FEC based AM unlock (Comment #67)

AM unlock

Proposed Solution for 802.3bs

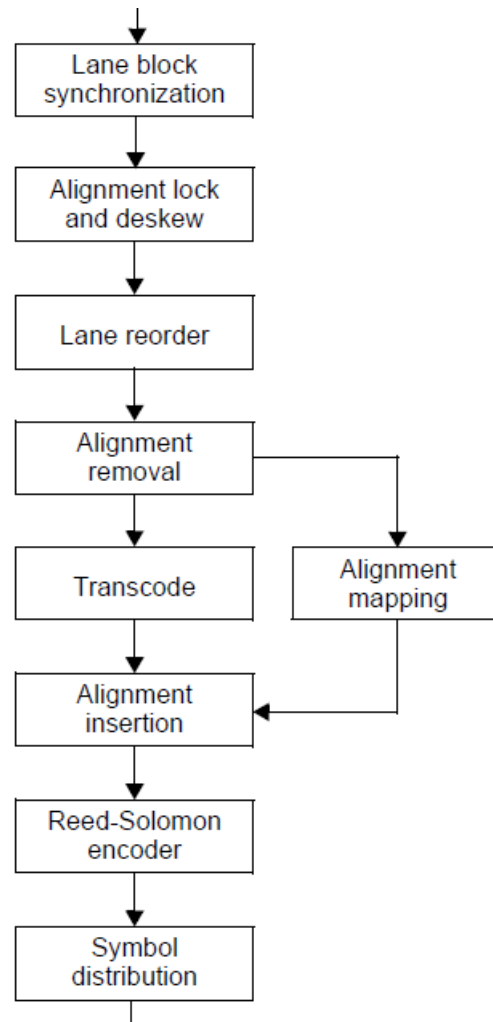
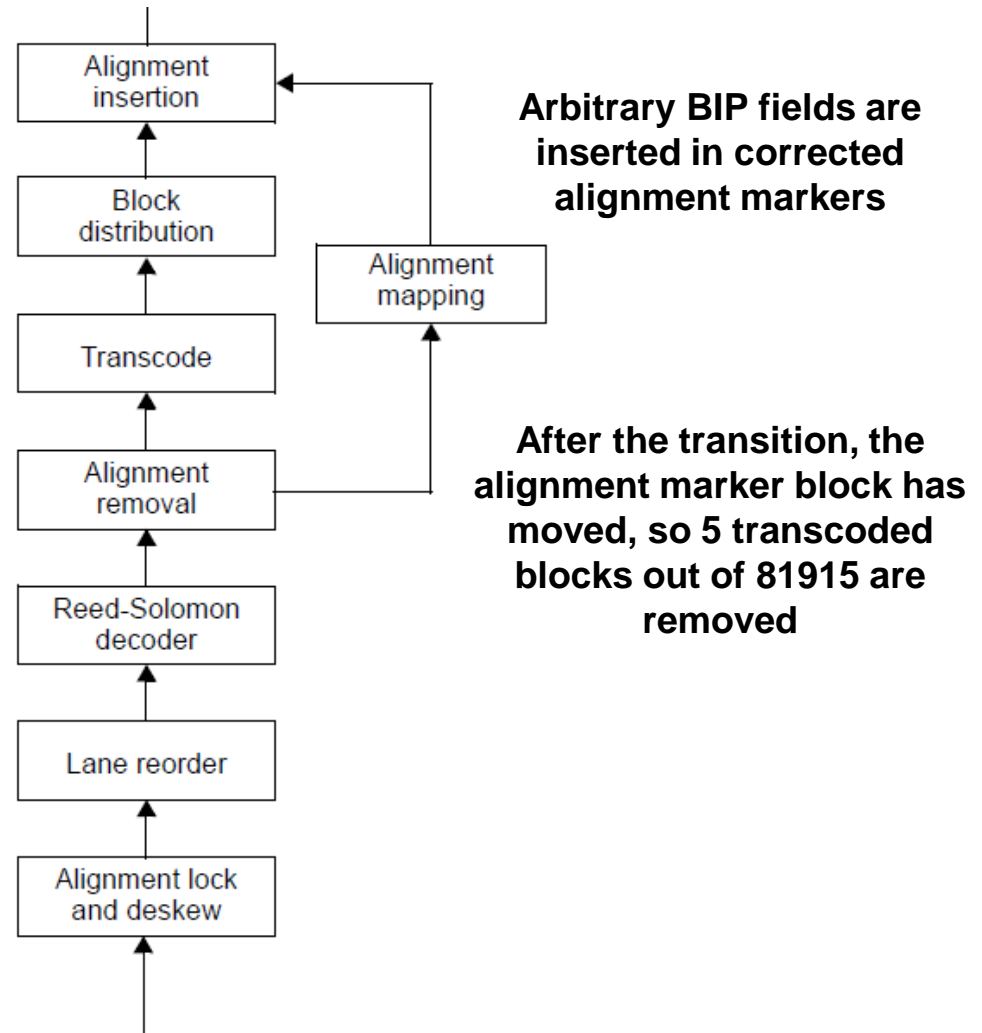
When fault is repaired, signal here changes from Ethernet containing LF generated at ingress node to Ethernet from remote client

Position of the AMs in the two signals is different

Reed-Solomon encoder may continue to send valid codewords throughout transition

PCS sees sync header violations from transcoder, an invalid BIP ratio of 0.996 and loses some frames, but the link stays up

Transcoder “decodes” the AM block

Reed-Solomon decoder see continuous stream of valid codewords

Alignment lock is only lost for 3 consecutive uncorrectable codewords

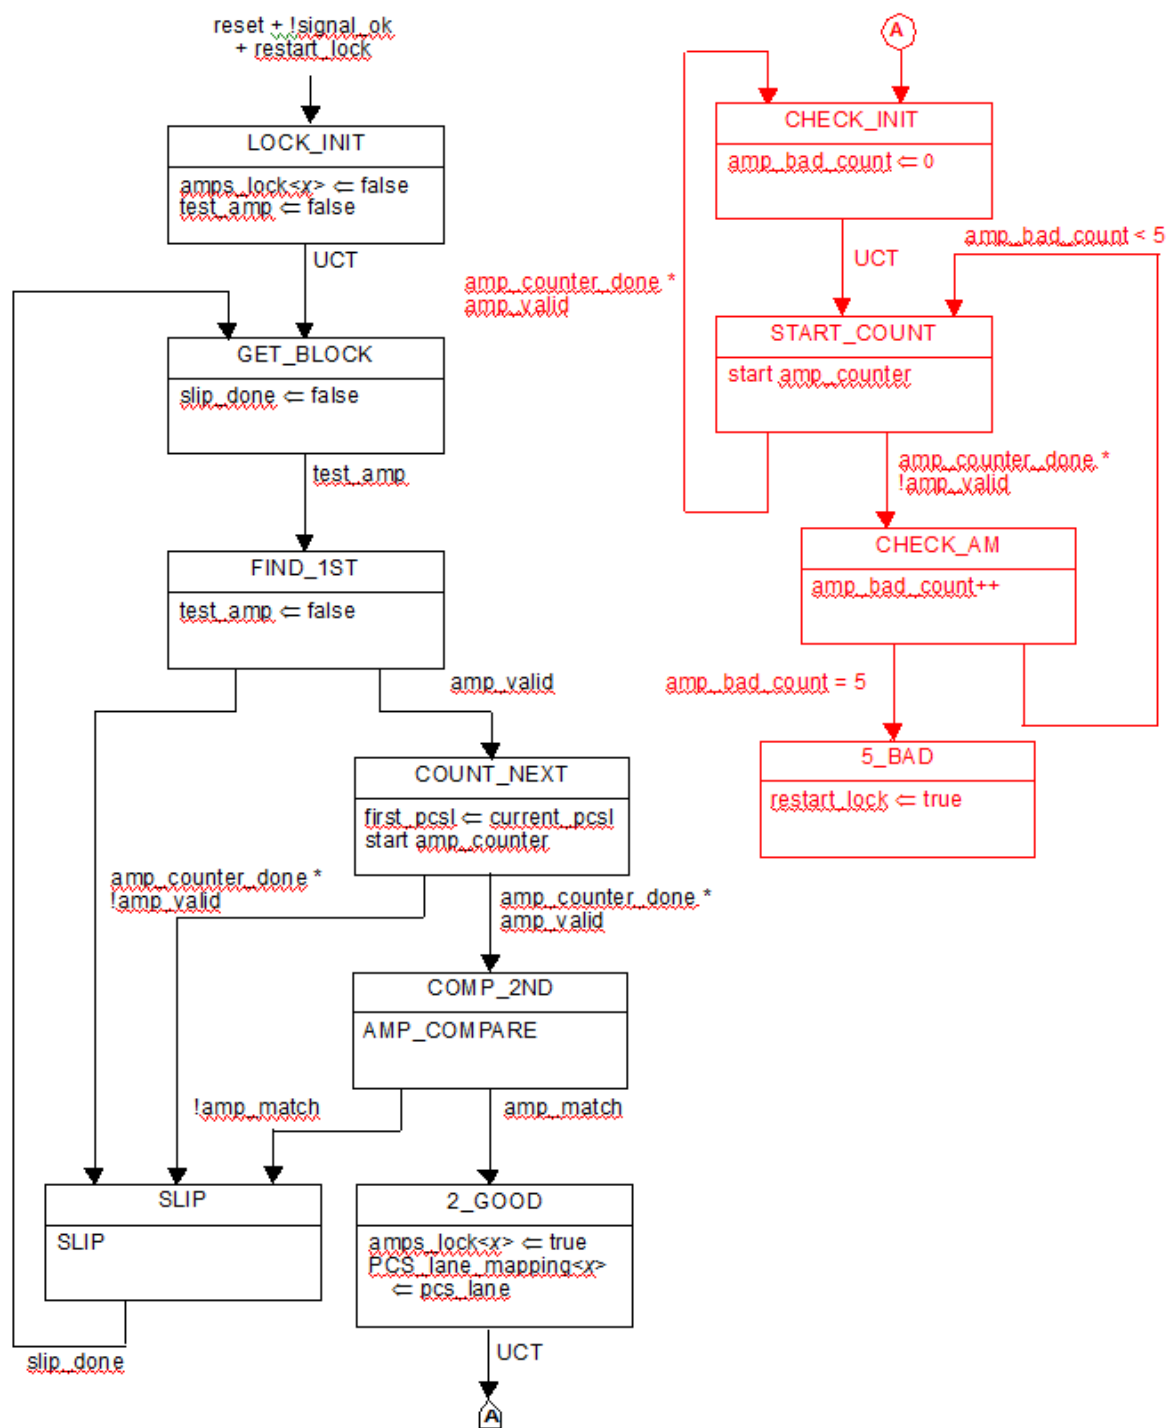
For the Clause 91 and Clause 119 FEC receivers, AM lock is found according to Figure 91-8 or Figure 119-12. These state machines look for two consecutive valid alignment markers in a row.

Once AM lock is achieved, these state machines do not continue to look at the AMs, but only go out of AM lock when 3 consecutive FEC codewords are uncorrectable (Figure 91-9 and Figure 119-13).

restart_lock

Boolean variable that is set by the PCS alignment process to reset the synchronization process on all PCS lanes. It is set to true after 3 consecutive uncorrected codewords are received (3_BAD state) or when 5 Alignment Markers in a row fail to match (5_BAD state) and set to false upon entry into the LOSS_OF_ALIGNMENT state.

amp_bad_count

Counts the number of consecutive alignment markers that don't match the expected values for a given PCS lane.
